Enclosed please find eight copies of the revised pages to convert Revision 10 of the OH-142 Safety Analysis Report to Revision 11 of that report. Also enclosed is the required check for \$150 to initiate the minor revision process.

MODEL OH-142 SHIPPING CONTAINER

REVISION 11

EXPANSION OF ACCEPTABLE STRESS-STRAIN RANGE FOR IMPACT LIMITERS

FIGURE 1.10.2-1

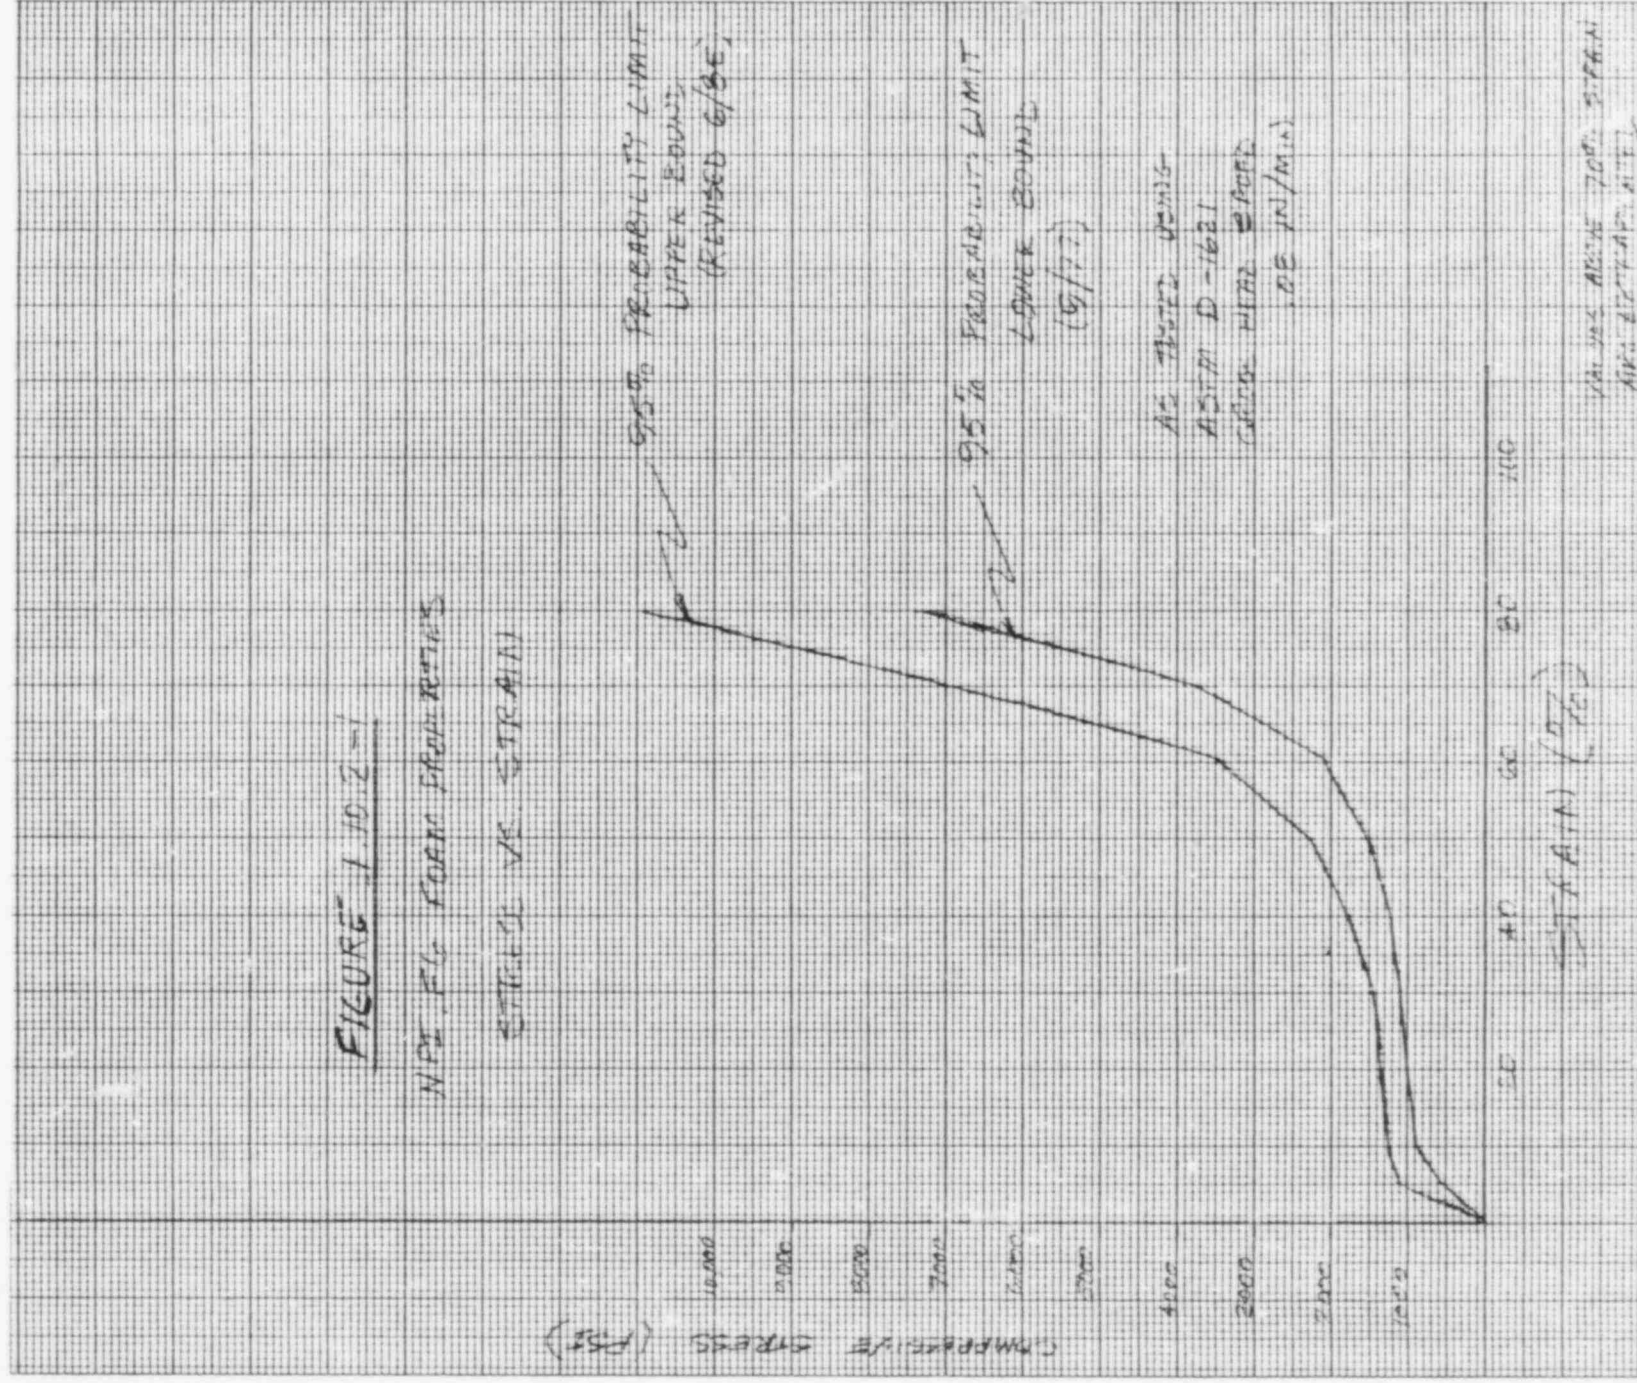
Due to minor changes in the formulation of the NPI.F6 polyurethane foam used in the OH-142 overpacks, it has become apparent that some foam placed in accordance with it may not exhibit stress-strain properties as shown in Figure 1 of Section 1.3 above. Some samples of foam taken during fabrication activities indicate that the upper bound of the stress-strain curve in Figure 1 should be raised. The revised limits of the stress-strain curve are shown in Figure 1.10.2-1. An analysis of the effect of this revised upper bound on the package margins of safety is presented below.

The end impact drop orientation is the drop orientation most seriously affected by the revised foam properties. NuPac's EYDROP program is used to evaluate the force generated from a 31 foot drop onto an unyielding surface. EYDROP, like its sister programs CYDROP and SYDROP, has been used to demonstrate compliance of several other packages (such as the T-3 Spent Fuel Shipping Cask, Certificate of Compliance No. 9132, and the NuPac PAS-1 package, Certificate of Compliance No. 9184) to the 10 CFR 71 drop events. Table 1.10.2-1 presents output from EYDROP for the OH-142 using the revised upper bound of the stress-strain curve as shown in Figure 1.10.2-1. The table was generated using the equivalent outside diameter of the package. This equivalent diameter is calculated by determining the actual end area of the overpack and finding that diameter of a circle which has the same end area as the actual overpack. Also, the analysis assumes the entire overpack area is effective, corresponding to both the most conservative assumption presented in the body of this report as well as the results of numerous test programs.

The table predicts that for the revised stress-strain limits, the acceleration experienced by the package would be 117 g's, slightly higher than previous analysis had predicted. The predicted deflection, 3.94 inches, is slightly less than previously predicted.
